**ADDENDUM NO. 5
IRONDALE PUBLIC LIBRARY**

CITY OF IRONDALE

THIS ADDENDUM FORMS A PART OF THE CONTRACT DOCUMENTS. THE FOLLOWING CONDITIONS TAKE PRECEDENCE OVER ANY CONFLICTING CONDITIONS IN THE DRAWINGS AND SPECIFICATIONS. THE DRAWINGS AND SPECIFICATIONS ARE HEREBY AMENDED IN THE FOLLOWING PARTICULARS.

C5.02

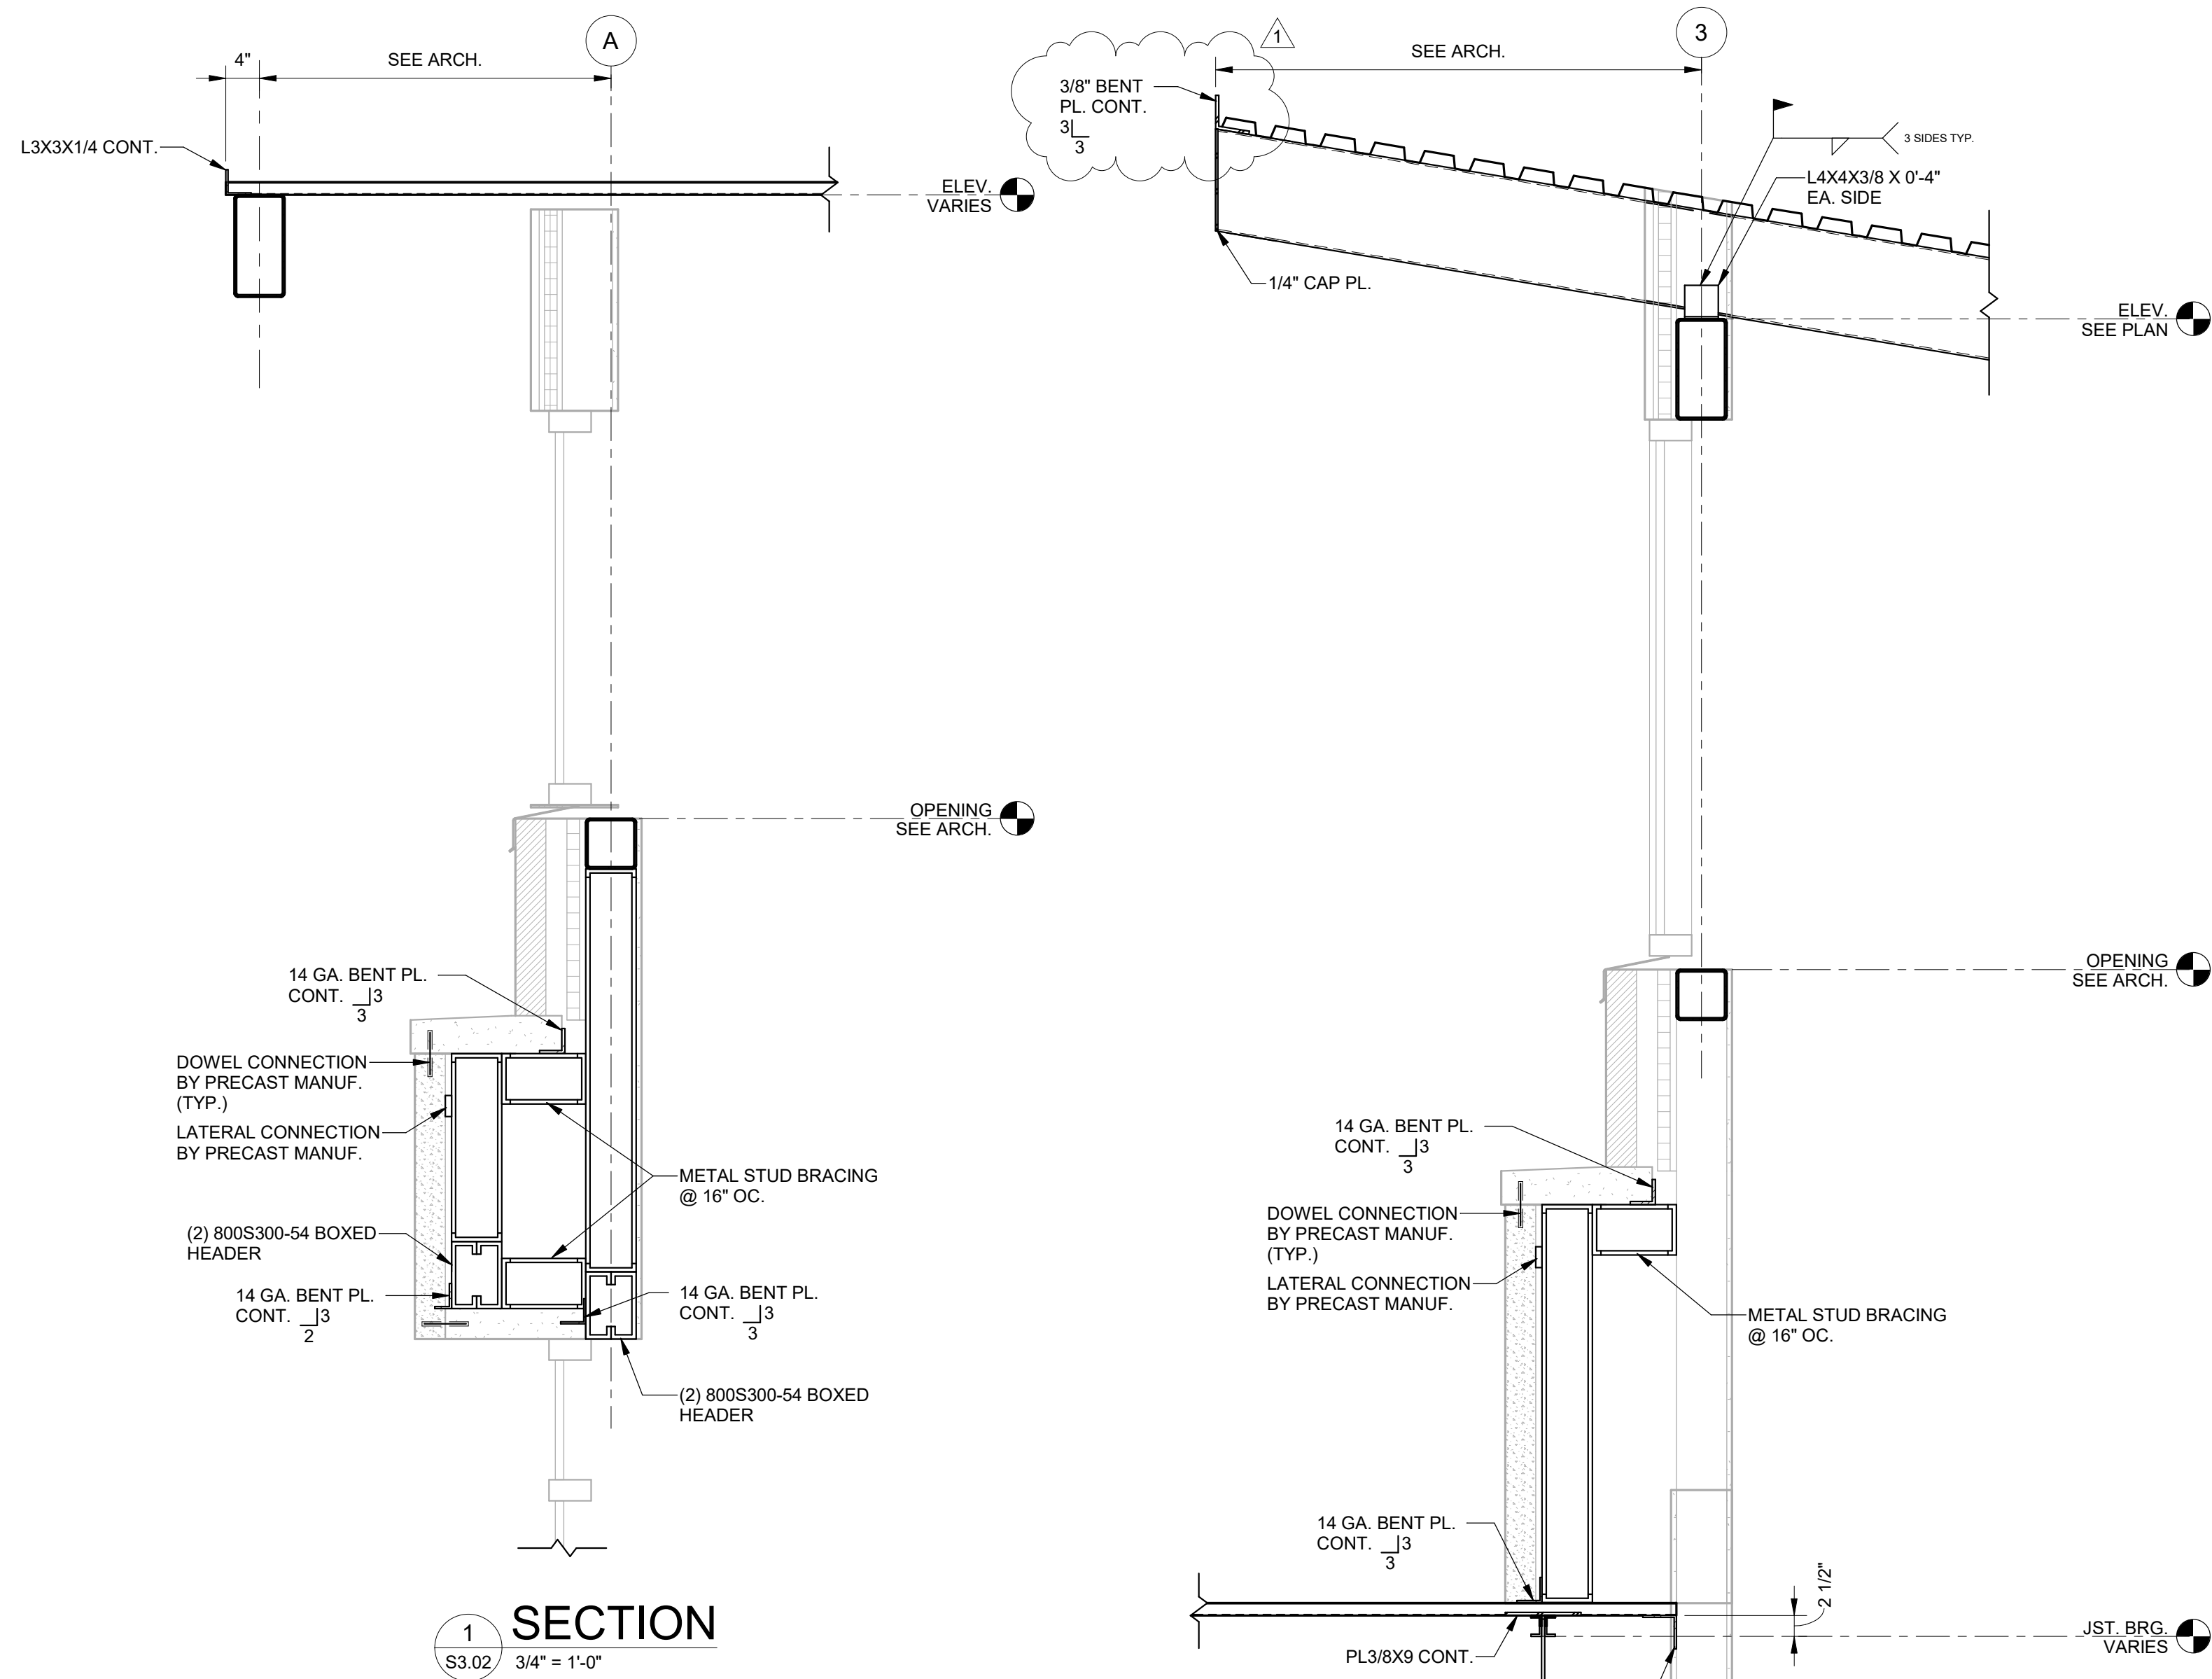
5. Sheet C5.01
 - a. Reprint sheet issued in Addendum 4 due to corrupted file.
6. Sheet C5.02
 - a. Added drain line behind building to profile view
 - b. Added bioretention cell detail

2 SECTION
S3.02 3/4" = 1'-0"

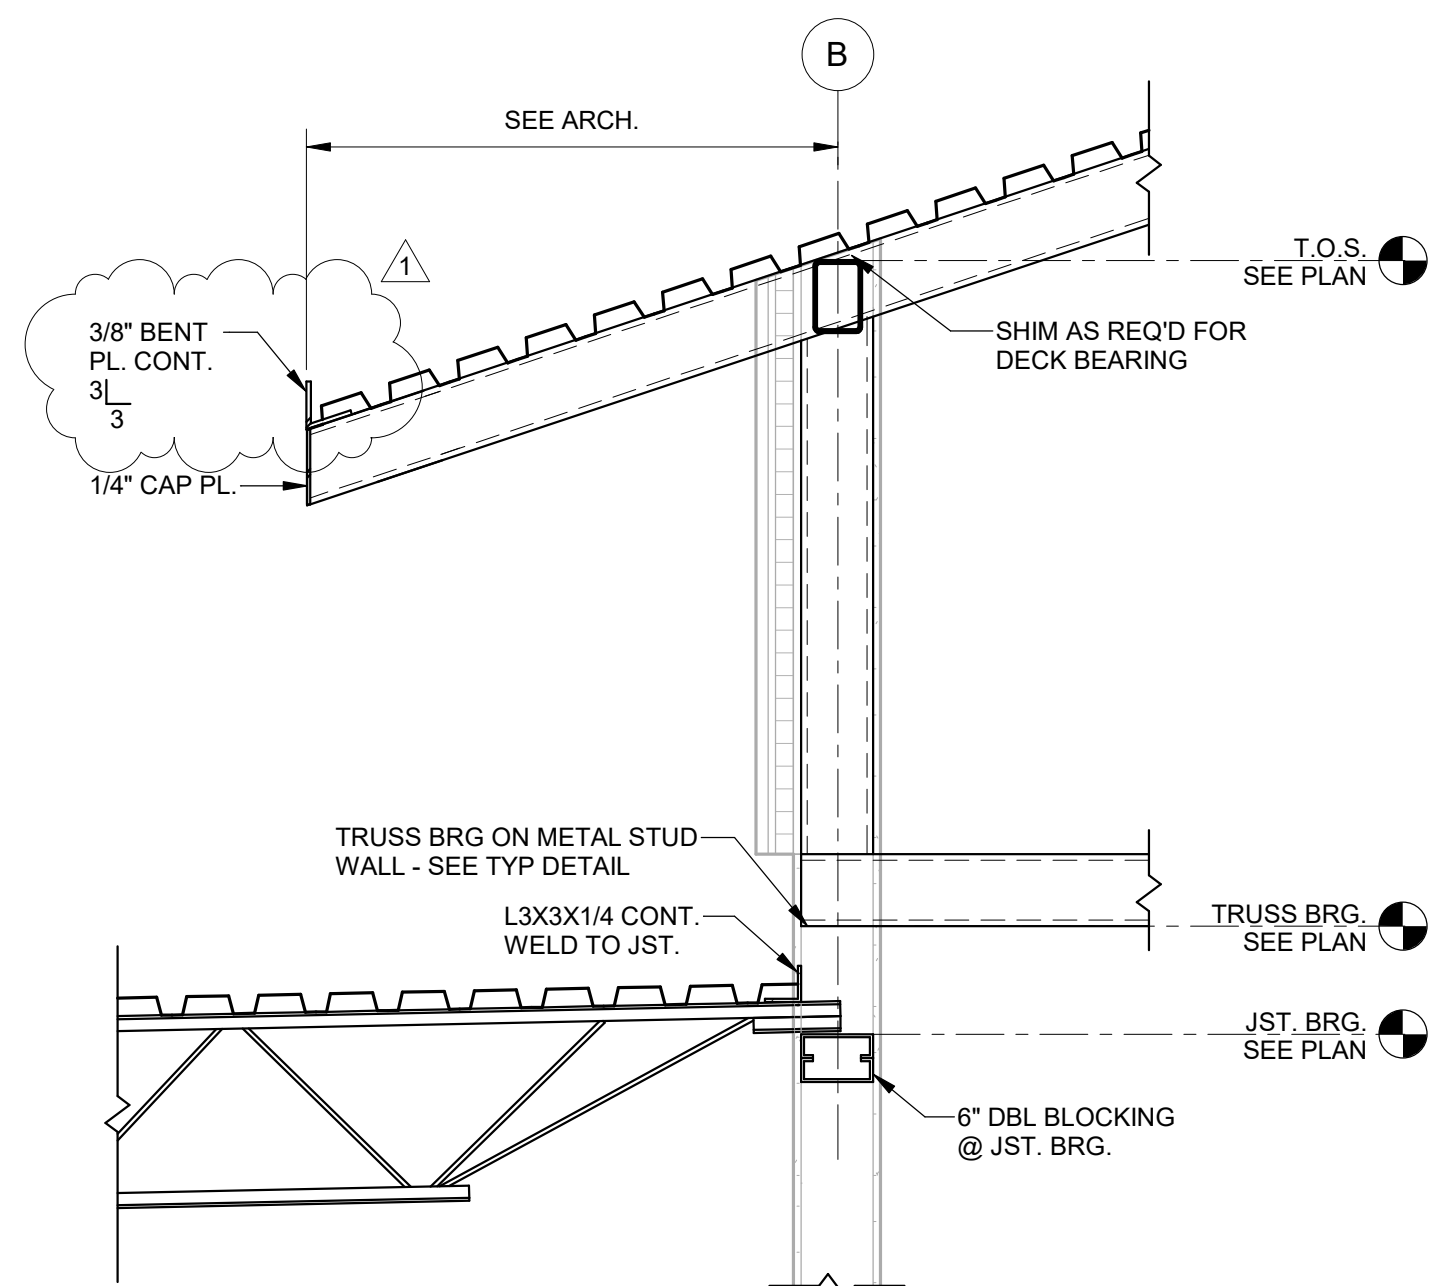
7. Sheet S3.02
 - a. Section 2 – 3x3 3/8" Bent Plate at roof
 - b. Section 4 – 3x3 3/8" Bent Plate at roof
 - c. Section 5 & 6 – Dimension note added
8. Sheet E002

SHEET NUMBER
E002

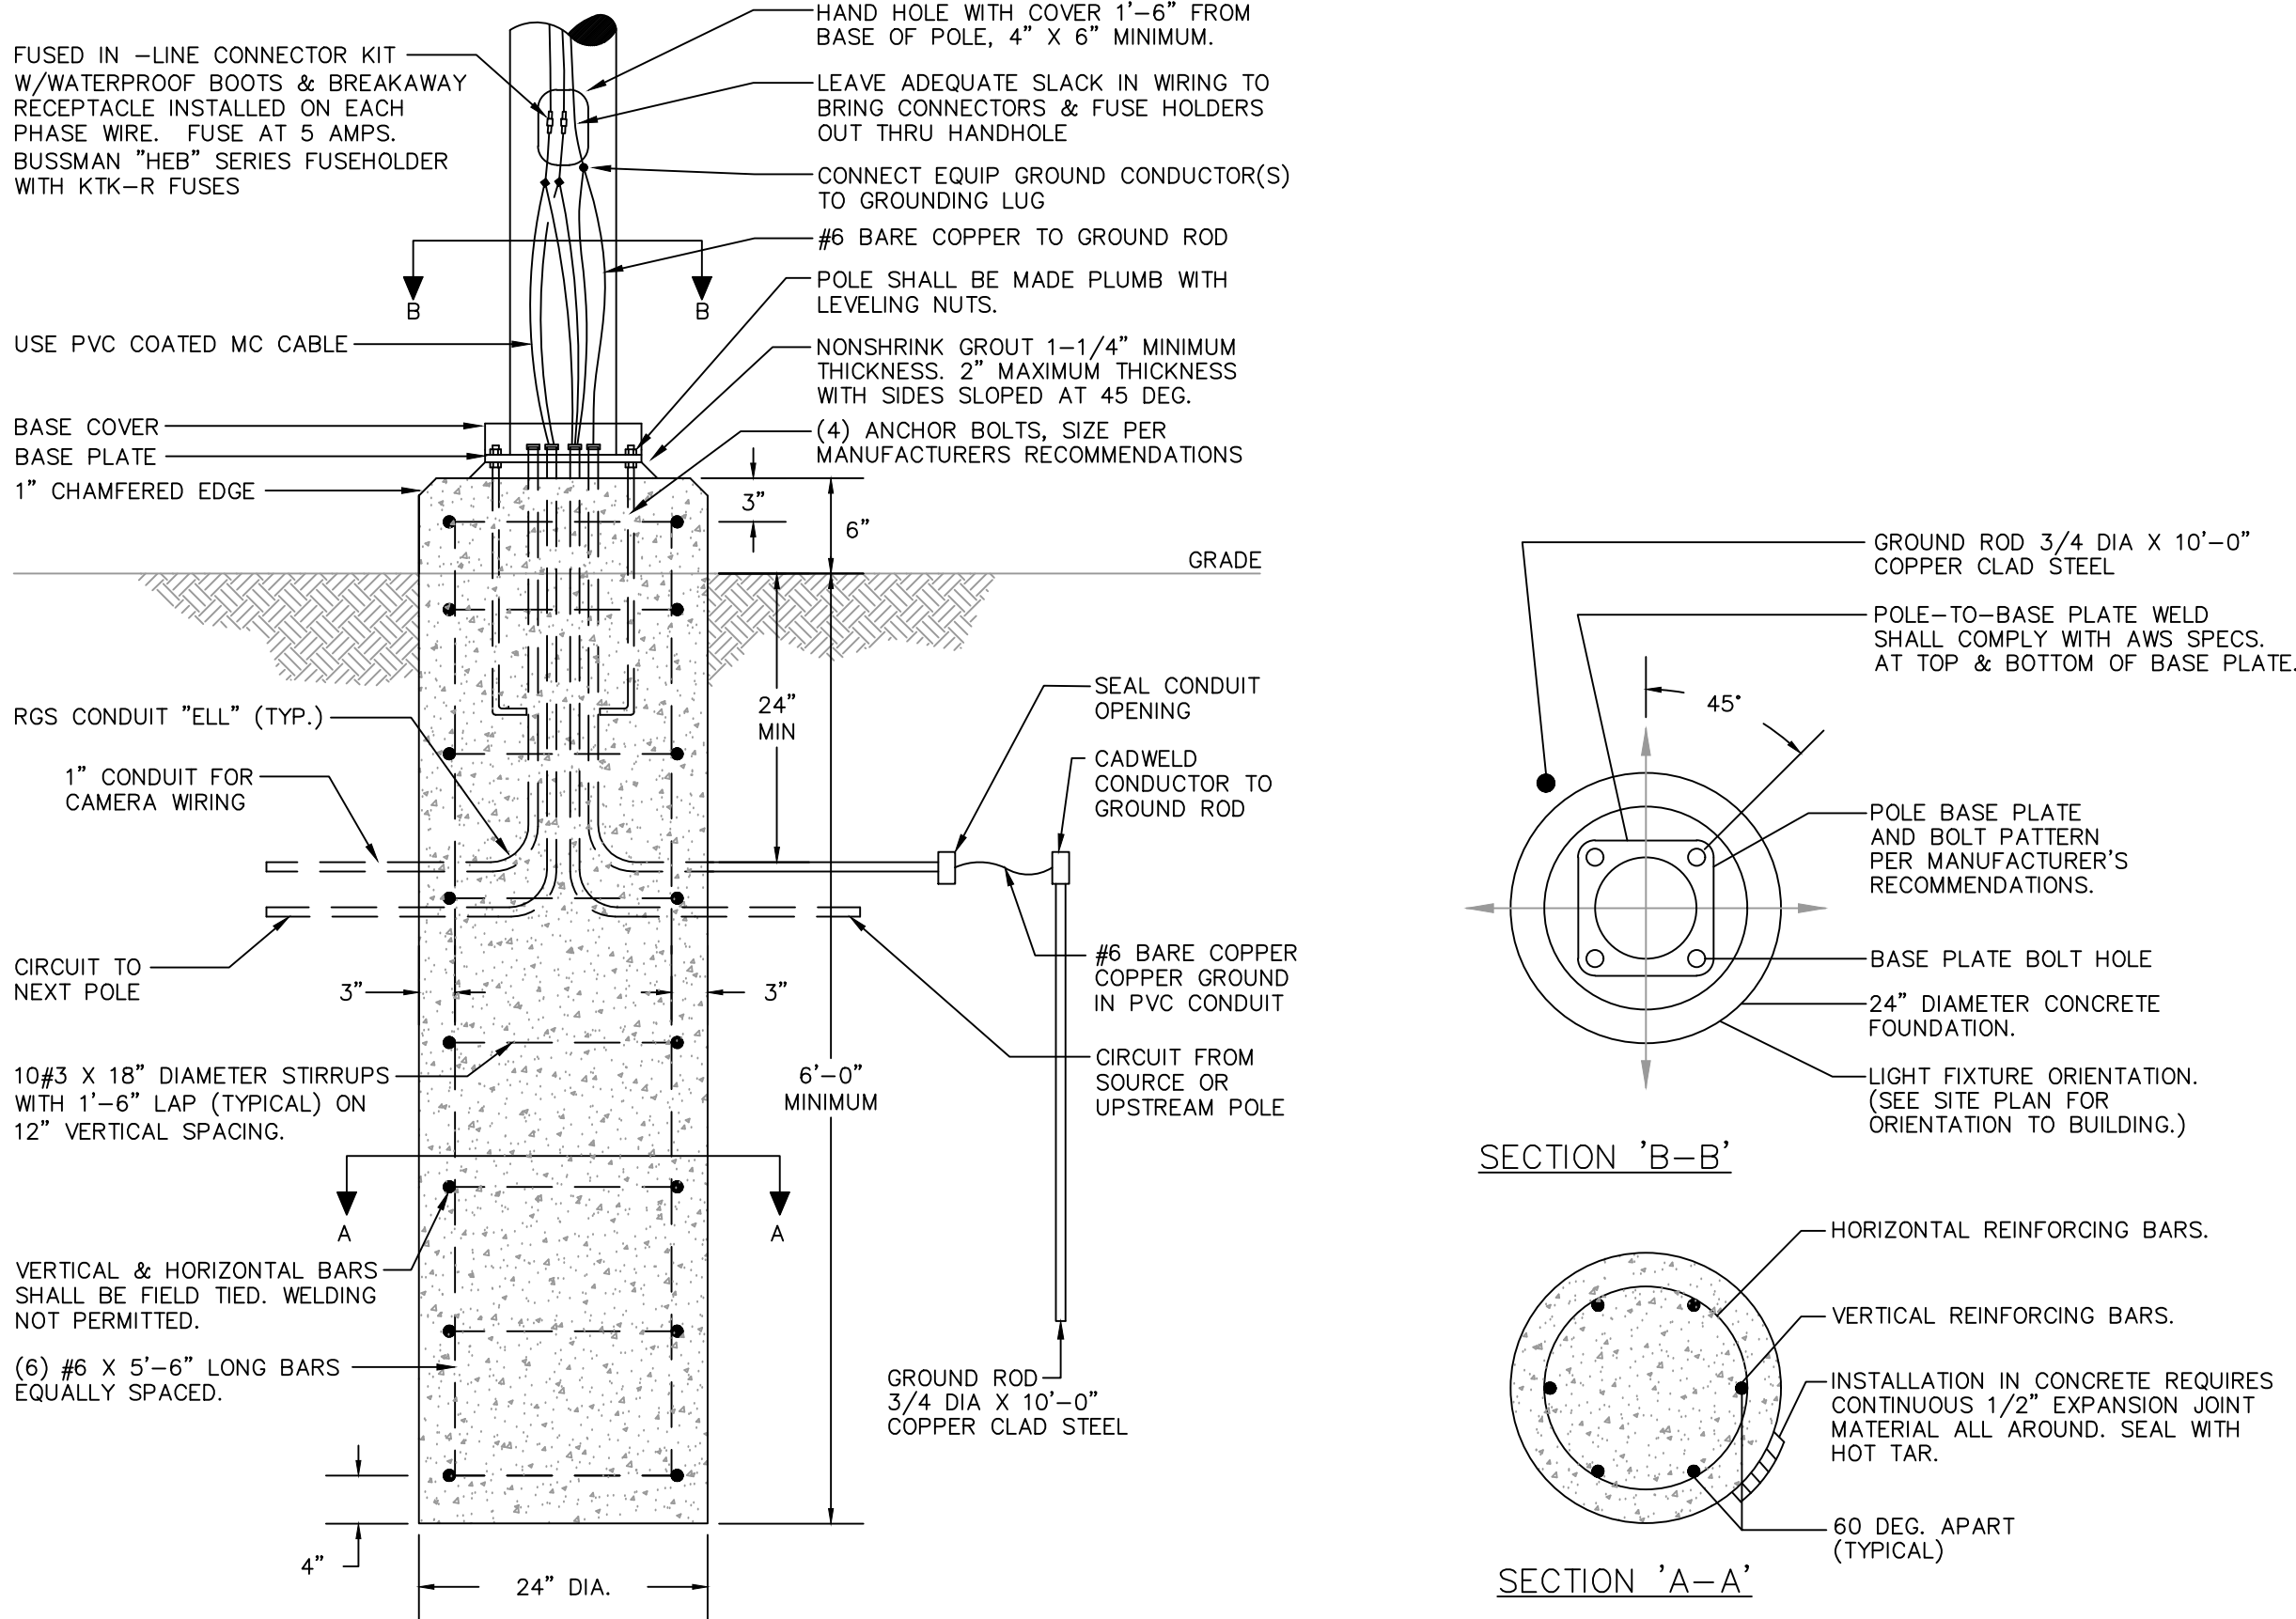
- a. Added Fixtures 'P5E', 'W2', and 'PL4'.
 - b. Updated Manufacturer and Model Numbers for Fixture 'P12' and 'P13'.
 - c. Updated description for fixture 'PL2'.

- 2. Light Fixture 'PL2' quantity of (3) on electrical drawing E101 is shown as a single head but on the lighting schedule on electrical drawing E002 fixture 'PL2' is listed as a double-head. Please clarify.

Response: Fixture shall be single head.
- 3. Light fixture 'PL4' quantity of (2) on electrical drawing E101 is not listed on the lighting schedule on electrical drawing E002. Please provide a part number.

Response: Added on attached revised sheets.
- 4. Light fixture type 'W2' quantity of (4) shown on the exterior of the building at entry 100 on electrical drawing E201 is not listed on the lighting schedule on electrical drawing E002. Please provide a part number.

Response: Added on attached revised sheets.
- 5. Light fixture type 'P13' as shown in comp. station 208 on electrical drawing E201 does not appear to be 14' long as noted on the lighting schedule on electrical drawing E002. Please clarify.
